Subject: Cascadia H04 A/C Lines

Models Affected: Specific Freightliner Cascadia vehicles with EPA10 engines manufactured August 28, 2008, through June 6, 2011.

Daimler Trucks North America LLC, on behalf of its Freightliner Trucks Division, is initiating Field Service Campaign SF455A to modify the vehicles mentioned above.

January 2012
SF455A

Fig. 1, A/C Line Installation

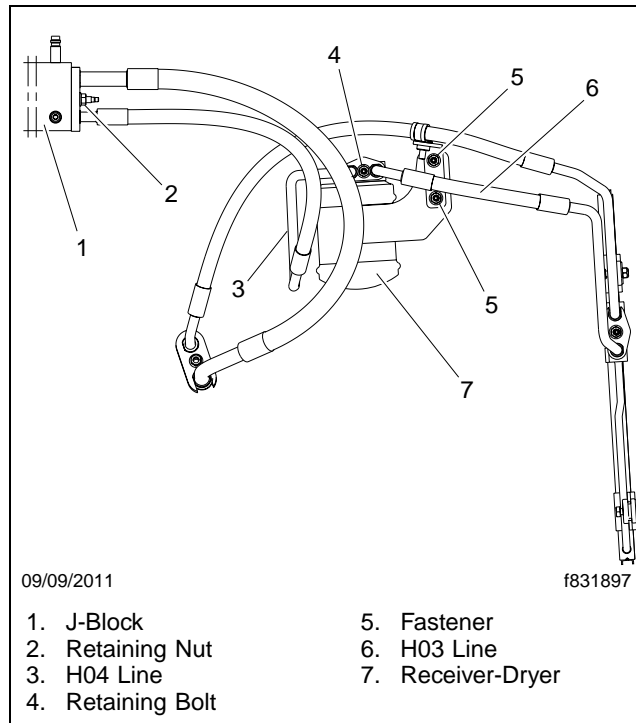
6. After the refrigerant has been fully recovered, disconnect the H04 line from the J-block and the receiver-dryer. See **Fig. 1**.
7. If the system lost complete charge prior to this procedure, replace the receiver-dryer as follows in this step.
If the system did not lose complete charge, proceed to step 8.
 - 7.1 Remove the mounting bracket fasteners, then remove the receiver-dryer. See **Fig. 1**.
 - 7.2 Position the new receiver-dryer, and install the mounting fasteners. Tighten 112 lbf·in (1266 N·cm).
8. Inspect all refrigerant lines and ports during assembly. The sealing surfaces must be clean and free of nicks, gasket residue, and other foreign material. Replace the seals on all connections that were loosened during the procedure (H01, H03, and H04).

9. Position the new H04 line, and using new seals, connect the line at the J-block and the receiver-dryer. See **Fig. 1**.
10. Using new seals, connect the H03 line to the receiver-dryer. See **Fig. 1**.

11. Tighten the fasteners on the receiver-dryer and J-block retaining plates 11 to 15 lbf-ft (15 to 20 N-m).
12. Drill a hole in the bottom of the removed receiver-dryer and drain the oil from it into an empty container. Measure the amount of oil recovered to determine how much to add back into the system.
